# CITY OF MILWAUKIE

## AGENDA

July 23, 2019

- 5.1 Summary: Elk Rock Estates (Continued from May 25, 2019)  
Applicant/Owner: Matthew Gillis, Gillis Properties  
Address: 12205/12225 SE 19<sup>th</sup> Ave  
File: NR-2018-005, LC-2018-001, WG-2018-001, VR-2018-014, VR-2018-015  
Staff: Vera Kolas, Associate Planner

Figure 4. FEMA Special Flood Hazard Area, Approximate Site Location Added in Red for Clarity (Unaltered Image in Attachment 6)

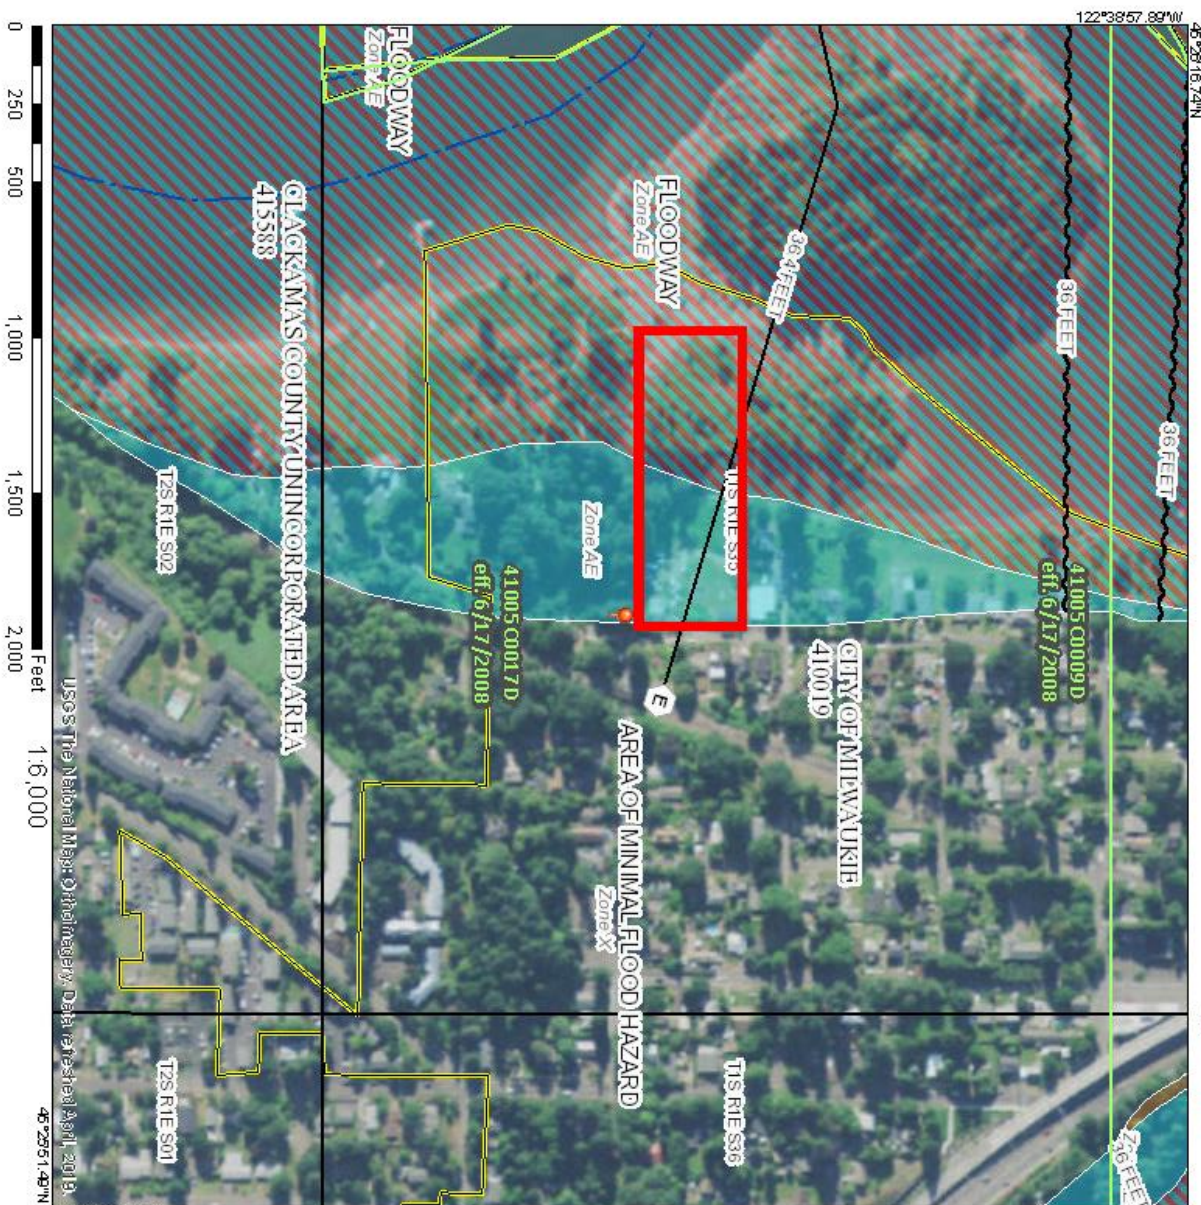
The FEMA mapped special flood zone on site is designated AE on the flood insurance rate map (FIRM, see figure 4). This zone is identified by FEMA as an area of flooding where high velocity flows are likely. Cross section E of the FIRM of the area intersects the site. The flood insurance study (FIS) of the cross-section identifies a mean floodway (which contains the slough) velocity of 5.9 ft/s. The floodway's mean velocity is not a good measure of actual flood velocity within the flood fringe but can be used as a general measure for an upper limit. The applicant is proposing to deviate from this FEMA guidance and data based on a model generated for a different project, with a different scope, by a party uninvolved in this application. Staff were unable to locate an associated LOMR on FEMA's National Flood Hazard Layer (NFHL) Viewer.

Figure 6. Site Plan

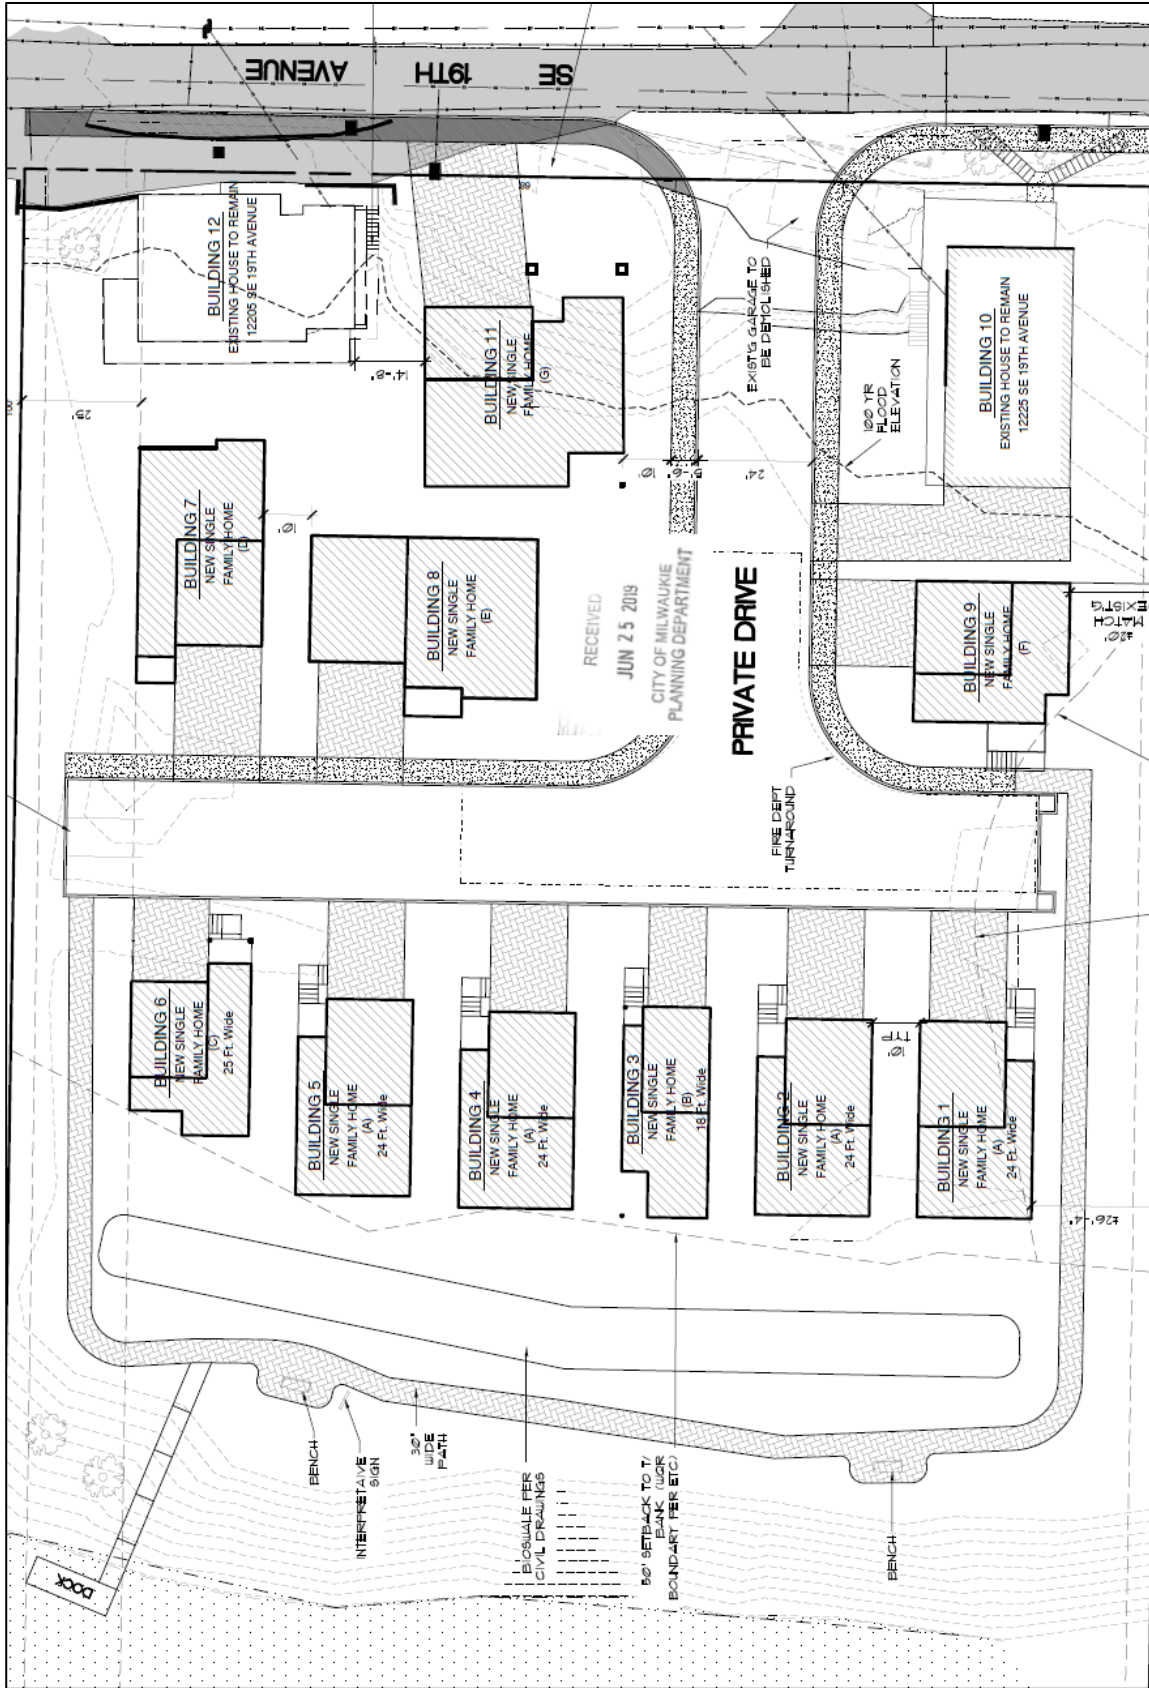
The applicant has identified the FEMA 100-year flood elevation, FEMA floodway, and ordinary high-water mark on provided plans. The applicant has proposed 1,853.42 cu ft of cut and 1,763 cu ft of fill, for a net cut of 90.36 cubic yards in the FEMA floodplain. Milwaukie code requires balanced cut and fill within both FEMA and Metro floodplains. The applicant has not identified or shown cut and fill information for the areas of inundation for the February 1996 flood. Additionally, the City of Milwaukie requirements for excavation and fill within the floodplain prohibit excavation below bankfull stage from

The development requires a private street to provide access to nine of the new homes one of the existing homes to be renovated. The City's comprehensive plan states in chapter 3, objective 1, policy 3, "(T)he finished elevations of the lowest floor of buildings and streets will be a minimum of 1.0 foot above the 100-year flood elevation." Standards set forth in the comprehensive plan must be met by this proposed development to satisfy the approval criteria of Willamette Greenway review. The applicant has provided elevation of the proposed road at a crowned center line. The lowest elevation of the private road occurs on Accessway 2 at station 0+26.00. The centerline elevation is marked at 37.4 ft. This would produce elevations at the edge of road of 37.16 ft, 0.24 ft less than the required one foot above BFE required by City policy.

The enclosed garages represent added enclosed space below BFE that will likely require professionally designed features to accommodate the hydrodynamic loading. If compliant openings are not feasible, the garage floor becomes the buildings lowest floor. This may require the garages to be raised one foot above BFE.

The new impervious area proposed requires engineered stormwater management. The applicant has proposed a stormwater treatment facility located within the floodplain. This stormwater pond facility is part of the proposed excavation necessary to meet balanced floodplain cut and fill. The applicant has proposed that detention will not be required. In general, according to the City of Milwaukie Public Works Standards section 2.0041, all developments will be required to provide onsite detention, unless the developer can demonstrate by a hydraulic analysis that proposed development will not increase stormwater runoff volumes or peak discharge and meets all requirements of the City's municipal discharge permit. All impervious areas of the development are proposed to be piped to this pond. Additional analysis has not been provided to indicate the pond can intercept the required stormwater and still provide floodplain storage during extreme events. Additional consideration may be needed to protect fish from becoming trapped in the pond during high flow events.

Figure 9. View corridors

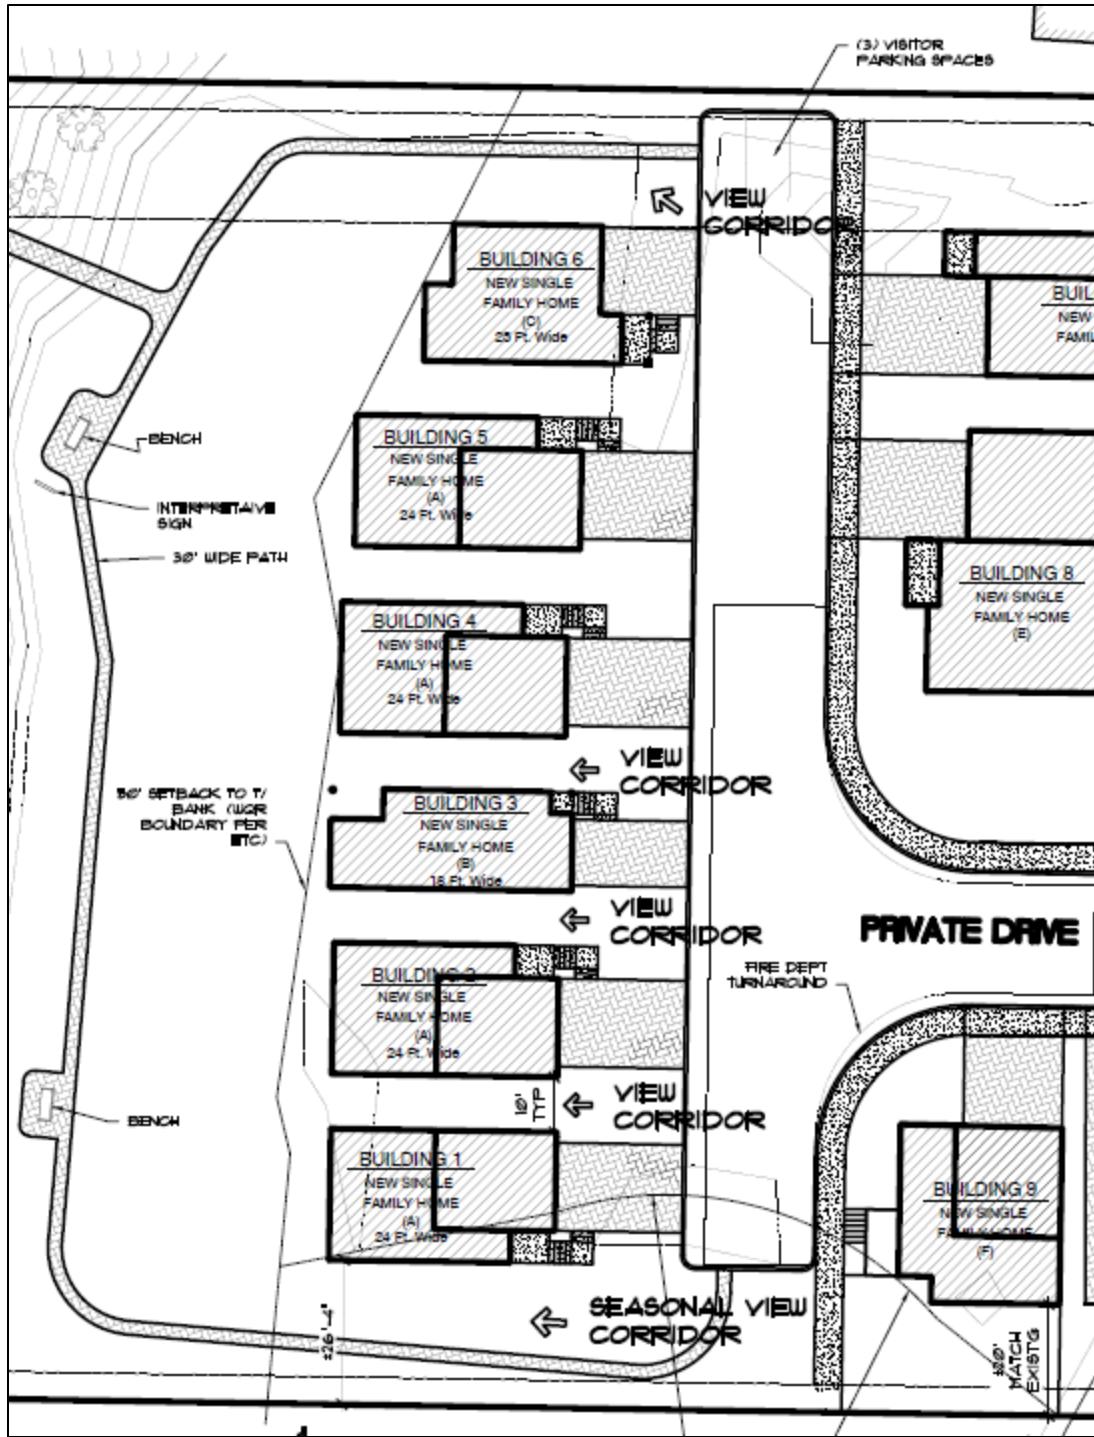
The presence of Elk Rock Island blocks any views directly west across the property, in addition to dense vegetation blocks views in the summer months. But, as shown above, there are portions of the river that are visible from the public right-of-way in the winter and spring. The proposed site plan identifies view corridors from the right-of-way (see Figure 9). It appears that the proposed development will provide some narrow views to the river. Numerous comments were received related to this issue and they unilaterally opposed the development based on its impact on views.

The overall views from the public right-of-way toward the river are limited today and do not appear significant enough to preclude approval of the WG conditional use application.

Figure 122. Site plan showing proposed 3-story homes.

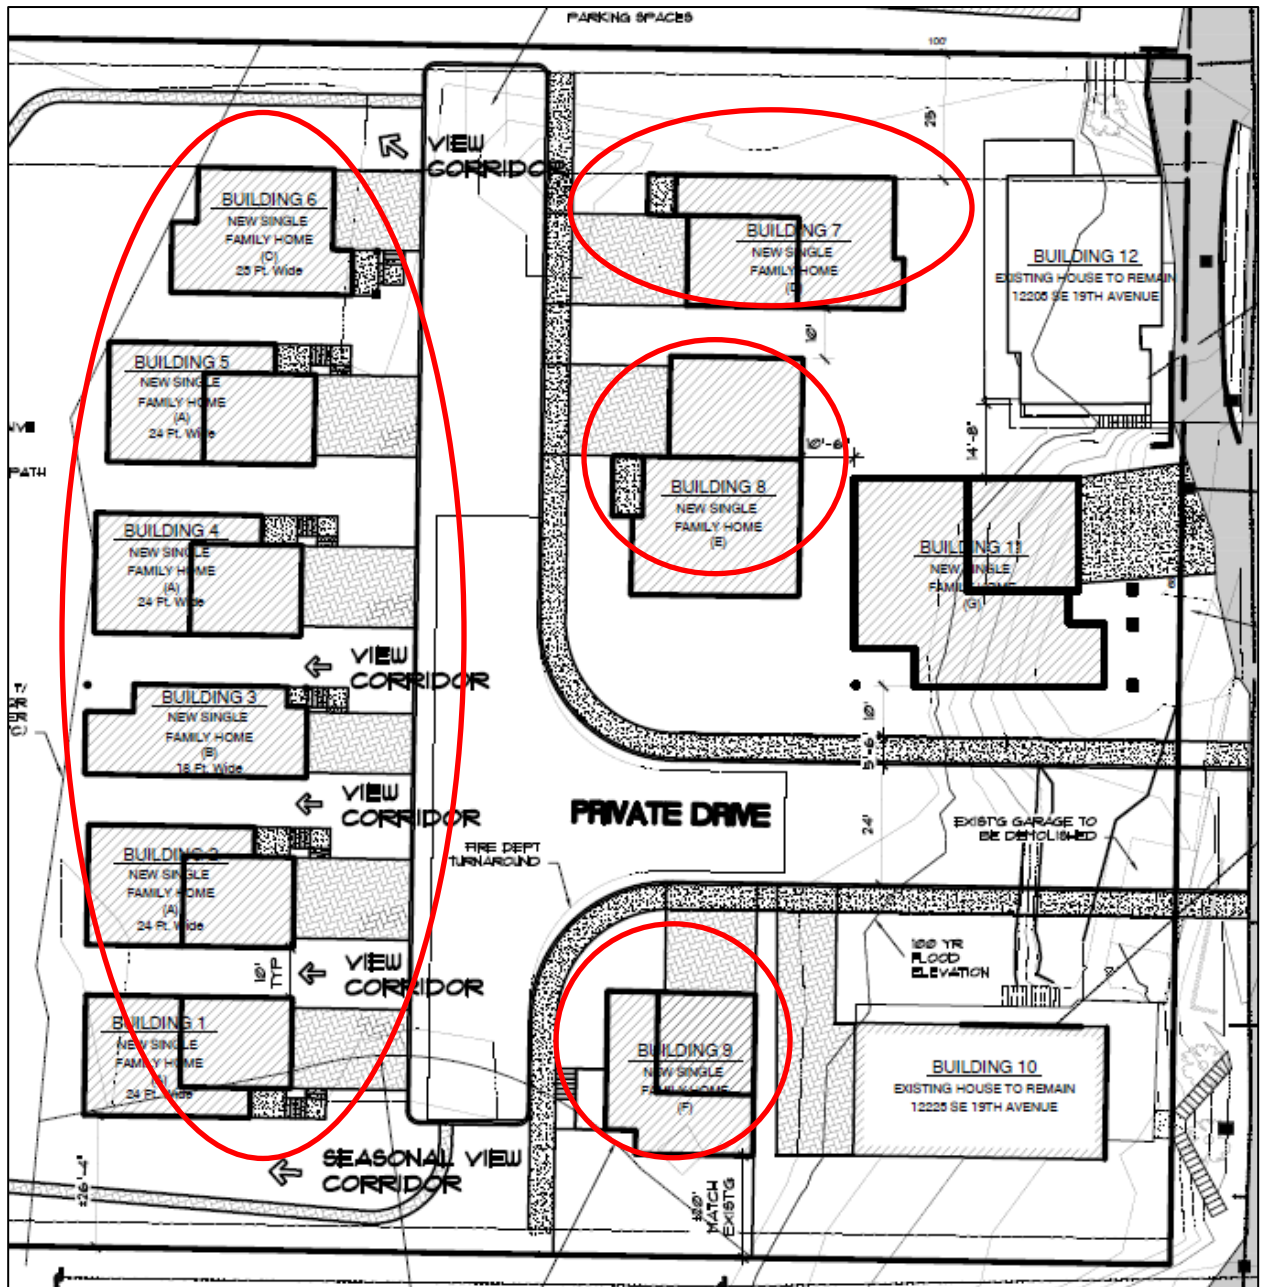
The variance is requested to allow for narrower footprints that would allow for a greater overall open space on the site, more efficient use of space, and because the "lower level" of these homes is not habitable space. The lower level can only be utilized as a garage or unfinished storage area due to FEMA and building code requirements. The applicant argues that since the proposed lower floor of these buildings is located within the floodplain and about 20 ft below the elevation of 19th Ave they will have less impact on views than two story homes constructed along 19th Ave (See Figure 12 for homes that require variance approval).

The height variance request is reasonable given the proposed home design, that the structures will comply with the measured height limit, and that the first floor is effectively not usable as living space.

Exhibit A: A possible design alternative that clusters development at the east end of the property to avoid/minimize floodplain and HCA impacts.

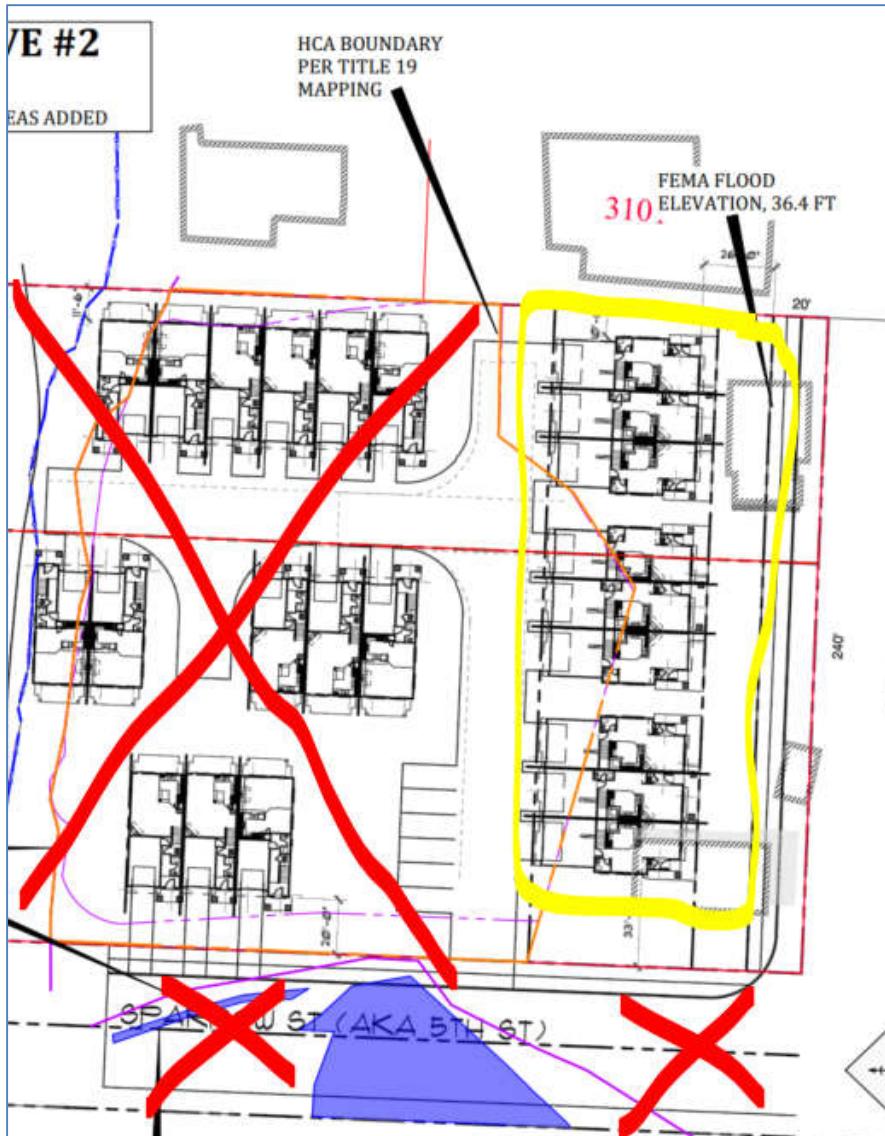
*Response: Alternative #4 (18 units) was added to the revised materials, but the application has failed to revise the impact analysis with detailed calculations of WQR/HCA impacts for each of the alternatives making it difficult to assess which one has the least amount of impact. Alternative #2 (23 units) is likely not a viable alternative anymore because it was developed before stormwater and floodplain no-net-rise issues were reviewed and addressed. Moreover, the revised materials do not include an alternative with a significantly different layout emphasizing attached dwellings or multifamily units clustered at the east end of the property in order to avoid/reduce impacts in the WQR/HCA mapped areas. A mark-up of a possible different design is based on Alternative #2, but eliminates a majority of the units within the floodplain. A question to ask the applicant is: are they willing to reduce the number of units to 9 to significantly avoid and minimize floodplain and HCA impacts? Would a 9-unit development still be a viable project? See Exhibit A below.*
